**Economic and Social Council**Distr.: General  
24 July 2013

**World Forum for Harmonization of Vehicle Regulations****Working Party on General Safety Provisions****105<sup>th</sup> session**

**Regulation No. 110 (CNG vehicles)****Proposal for amendments to ECE/TRANS/WP.29/2013/101:  
draft Supplement 1 to the 01 series of amendments to  
Regulation No. 110 (CNG vehicles)****Submitted by the expert from the Netherlands\***

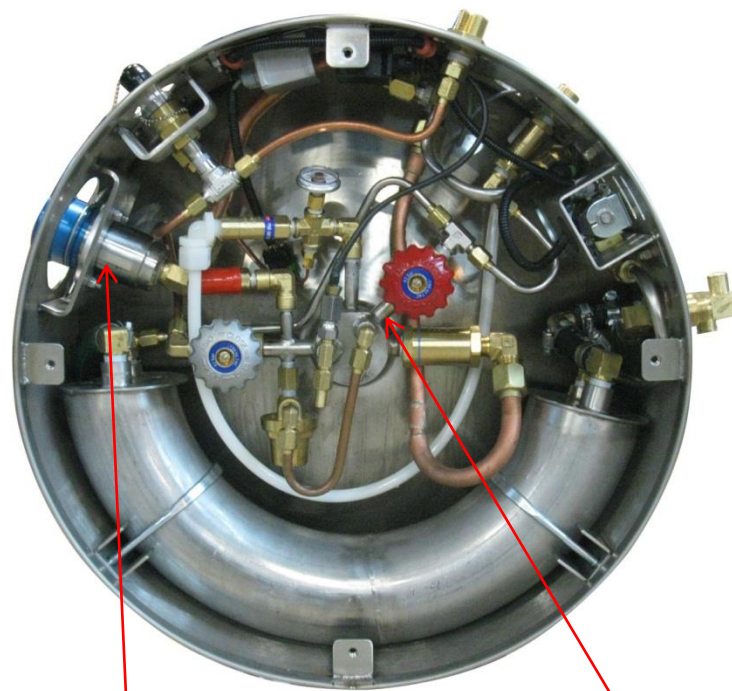
2. For LNG equipment, special care shall be taken to prevent LNG trapping. This can happen in case the automatic valve and manual valve are placed in series without taking any precautions.

"8.13.1. The LNG tank shall be equipped at least with the following components, which may be either separate or combined (**special care shall be taken to prevent LNG trapping**):

**18.6.1.1. An automatic valve shall be installed in the fuel supply line, directly on every LNG tank (in a protected position).**

The manual fuel shut off valve shall be mounted directly on the LNG tank (in a protected position). It should be readily accessible. **The manual fuel shut off valve can be integrated into the automatic valve."**
